**TREATMENT PLAN FOR THE SKULL VALLEY SEGMENT  
OF THE HASTINGS CUTOFF TRAIL,  
TOOELE COUNTY, UTAH**

Cultural Resources Report 5131-01-9916

Figure 16  
PFS Facility from Skull Valley Road

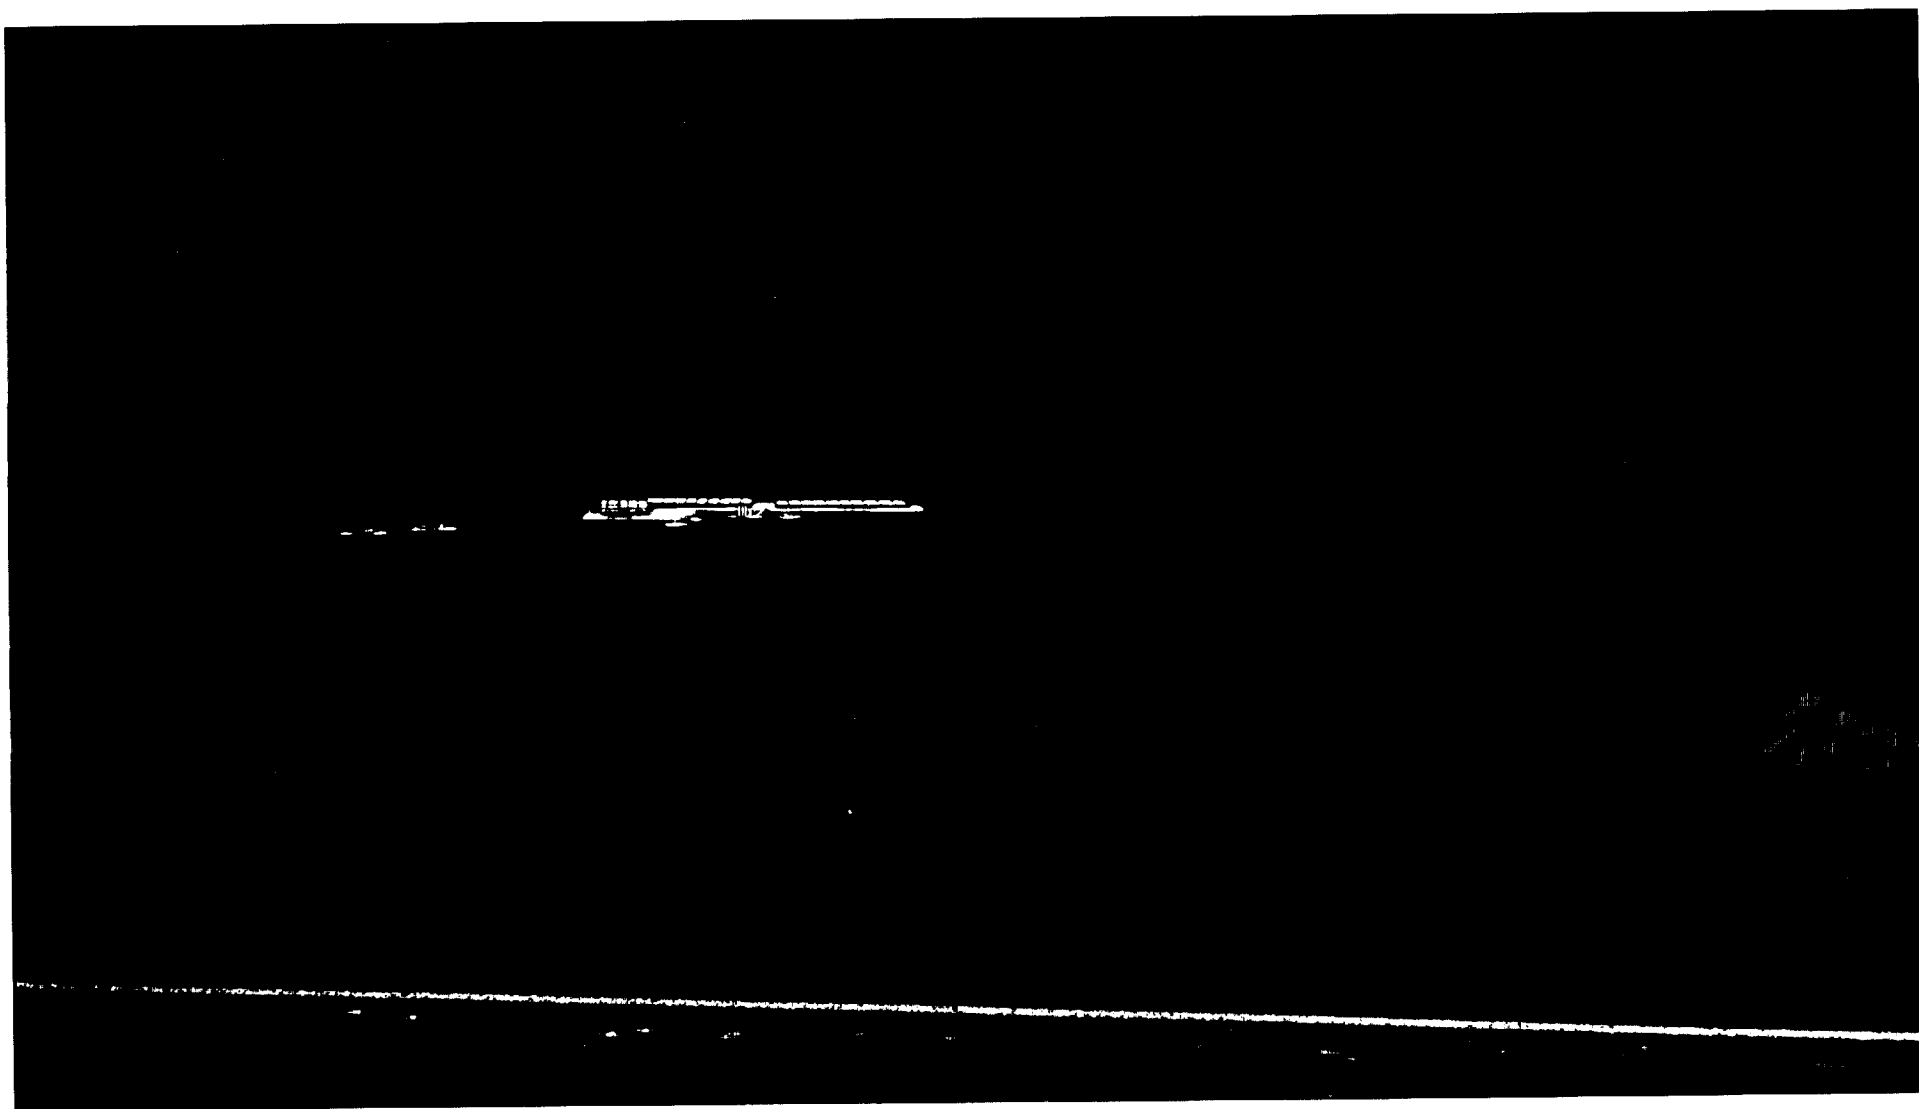
- 4-29 Provide sketches or artist renderings of the full facility (4,000 casks, batch plant, earthen berms, buildings, light poles, etc.), rail line and siding, and ITF.

FIGURE 16: PFS Facility from Skull Valley Road at Night -- From the same point as Figure 15, this is how the PFS Facility will appear with nighttime illumination.
